## DESCRIPTIVE REPORT

*Registry No.* ..... **H-11203**

*General Locality* ..... **Approaches to Prince William Sound**

*Sublocality* ..... **27 NM ESE of Hinchinbrook Ent.**

Figure 1 H11203 Survey Limits

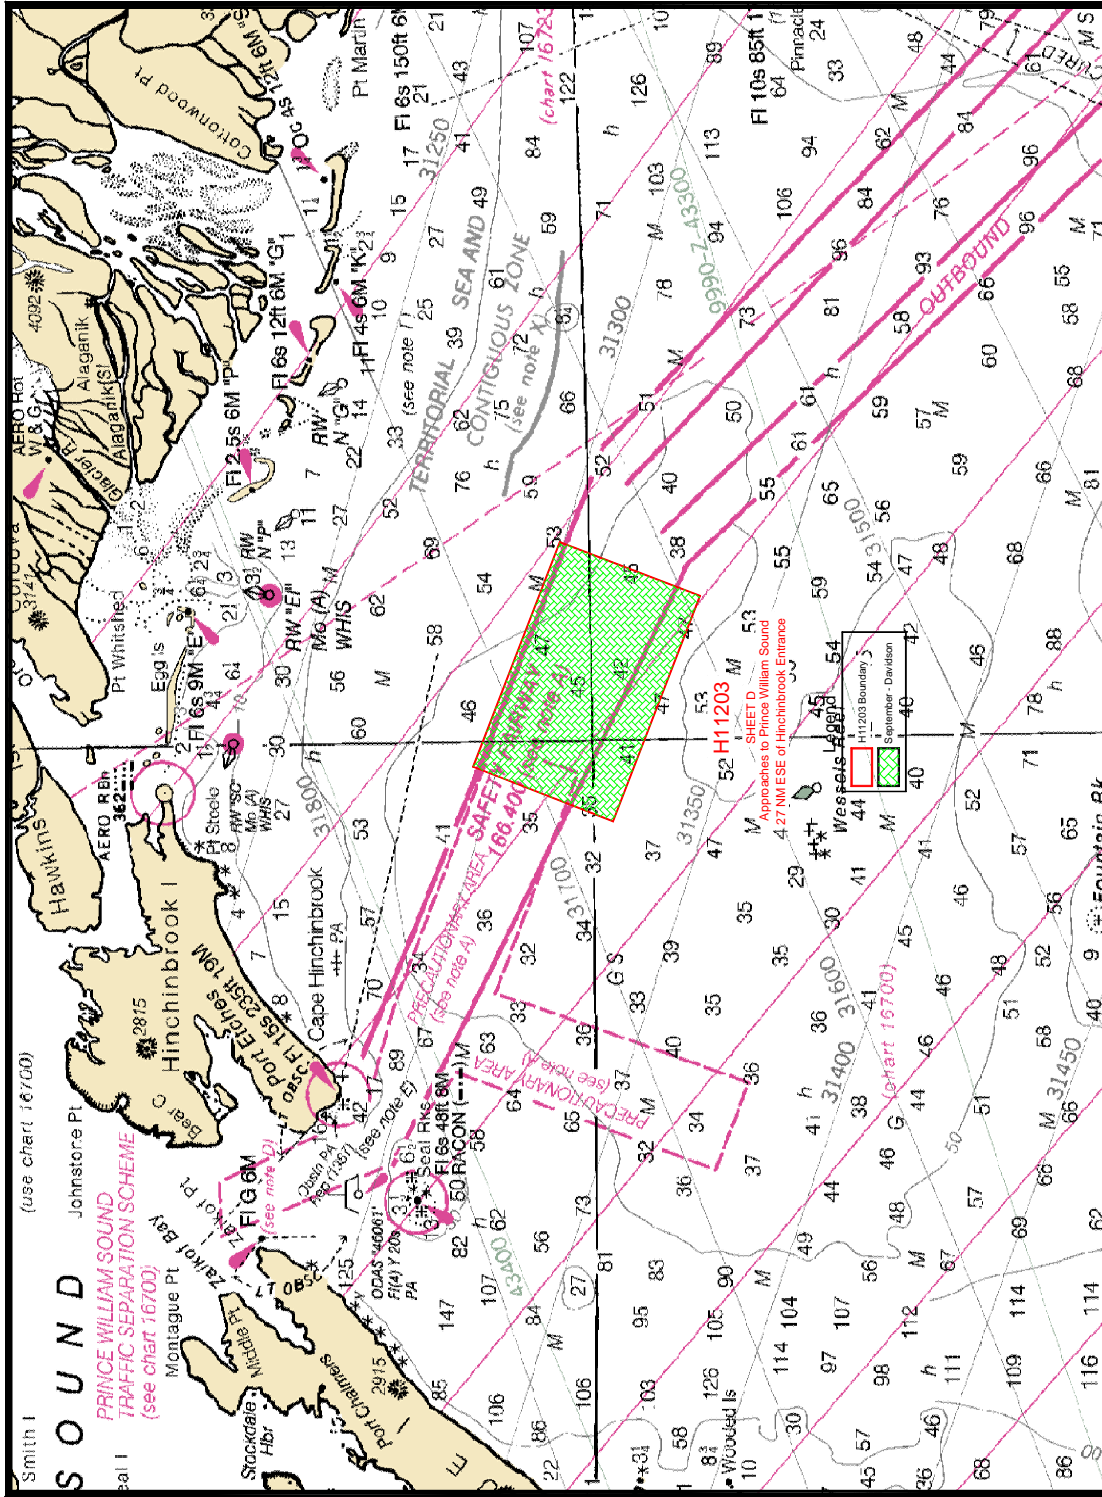
H11203 (Sheet D), is bounded by the coordinate listing below, and encompasses an area 27 NM ESE of Hinchinbrook Entrance.

Survey Limits Task Order # 12 H11203 Sheet D Scale 1:20,000		
Point #	Positions on NAD83	
	Degrees Latitude (N)	Degrees Longitude (W)
1	60°06'56.758" N	146°01'45.138" W
2	60°01'59.725" N	145°37'19.664" W
3	59°54'23.728" N	145°43'30.112" W
4	59°59'20.760" N	146°07'55.585" W
5	60°06'56.758" N	146°01'45.138" W

- <sup>1</sup> Revise sheet limits to the following:
  - 60/06/53N, 146/00/40W
  - 60/01/59N, 145/37/12W
  - 59/54/55N, 145/42/55W
  - 59/54/55N, 146/46/30W
  - 59/59/52N, 146/06/22W
- <sup>2</sup> Filed with the Project Records.
- <sup>3</sup> Concur. \_\_\_\_\_
- <sup>4</sup> PHB Revision--Strikethrough ~~ESE~~ and insert WNW.
- <sup>5</sup> PHB Revision--Strikethrough WNW and insert ESE.
- <sup>6</sup> Concur.
- <sup>7</sup> Filed with the Project Records.
- <sup>8</sup> Concur.
- <sup>9</sup> Concur with hydrographer's statements.
- <sup>10</sup> Concur.
- <sup>11</sup> Concur.
- <sup>12</sup> Concur.
- <sup>13</sup> Concur.
- <sup>14</sup> Concur.
- <sup>15</sup> Filed with the Project Records.
- <sup>16</sup> Filed with the Project Records.

**Figure 2 Sample SVP Plot**

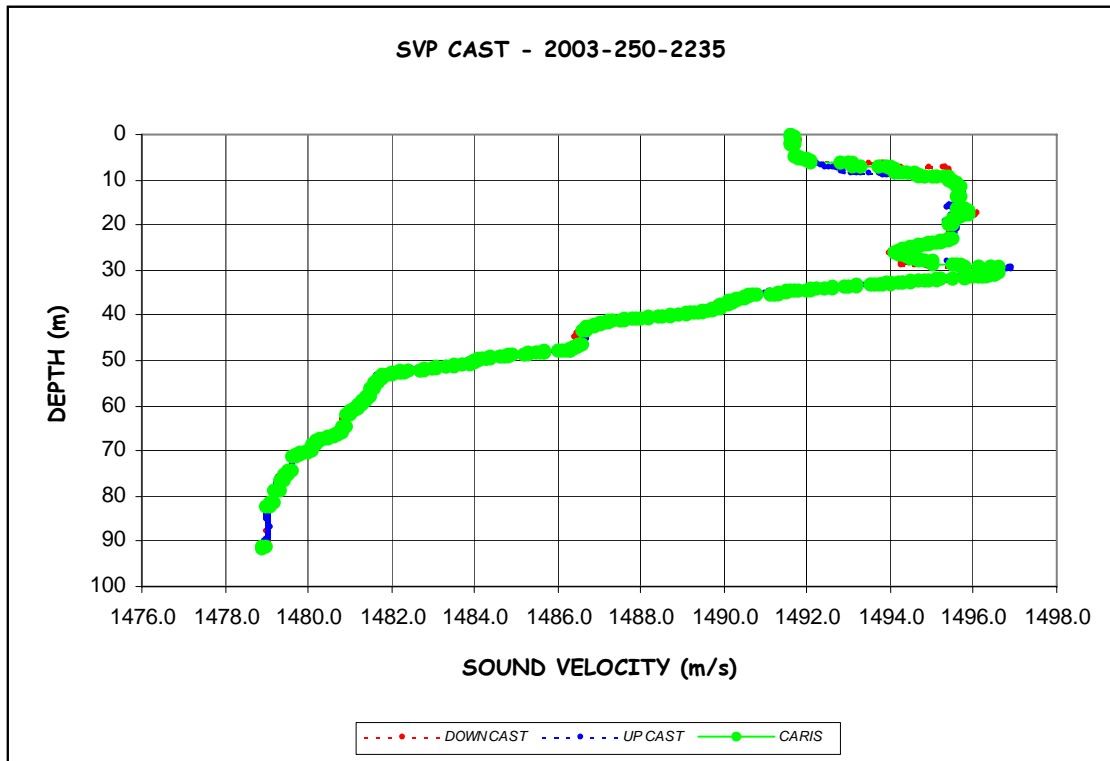
- During data acquisition and routine processing, a general downward and/or upward cupping was noticed in the across track sounding profiles for certain areas. This is possibly due to the high volume of thermal layering and strong under currents in the water column, an example of this can be seen in the figure below. In an attempt to resolve this cupping, SVP casts were conducted more frequently and line spacing reduced. (Refer to Separate 2 for SVP plots).<sup>3</sup>

**Figure 3 H11203 Survey Junctions**

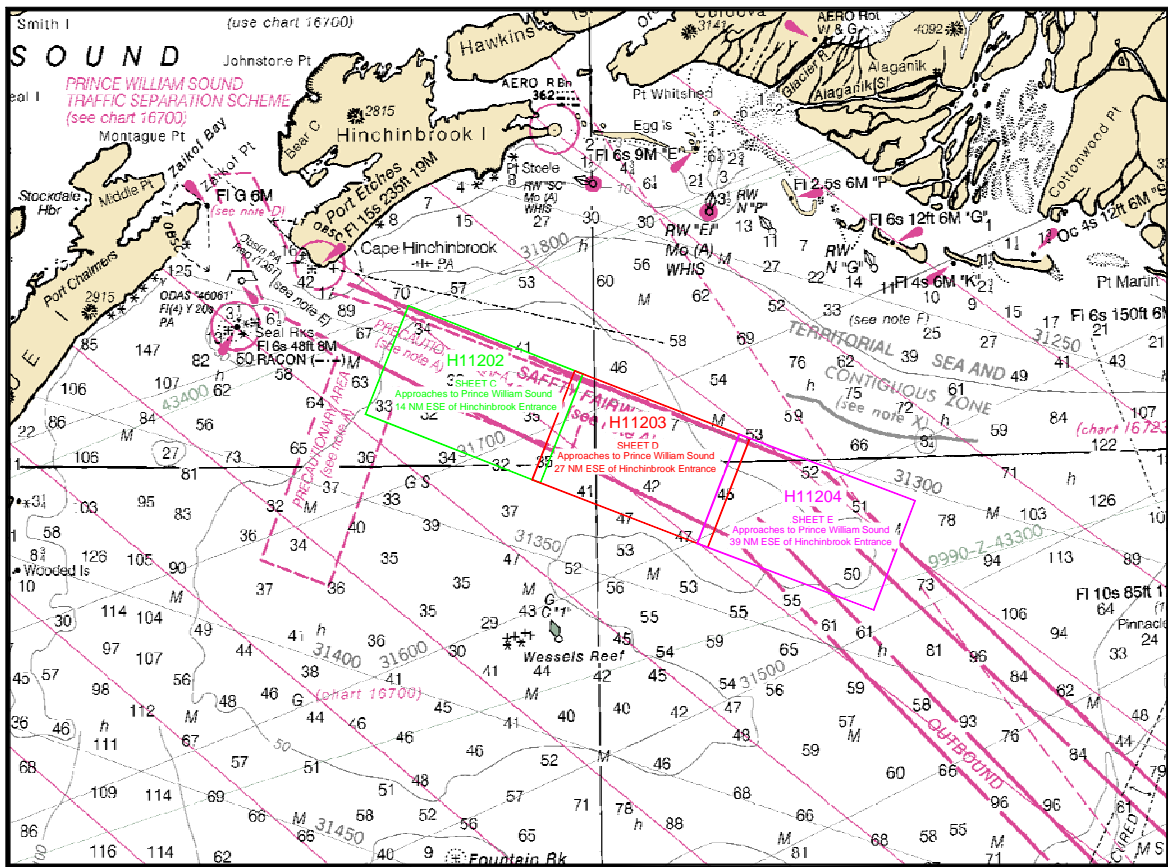
Registry #	Scale	Date	Junction Side
H11202	1:20,000	2003	ESE <sup>4</sup>
H11204	1:20,000	2003	WNW <sup>5</sup>

**Figure 5 Comparison of Contours**

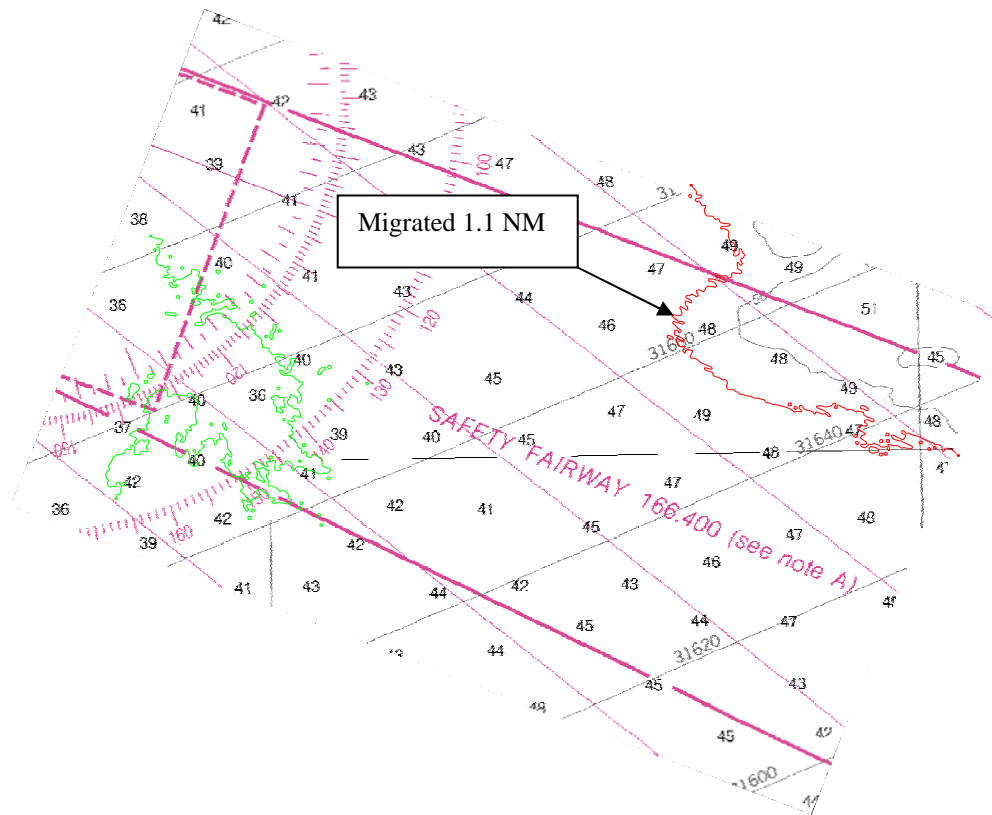
The soundings in general compare well with the existing charts.<sup>8</sup> Figure 5 Comparison of Contours reveals that the 50-fathom contour has migrated approximately 1.1 NM to the west from the existing one on charts 16013 and 16700. It should be noted that the 40-fathom contour is not present on the existing charts.<sup>9</sup>
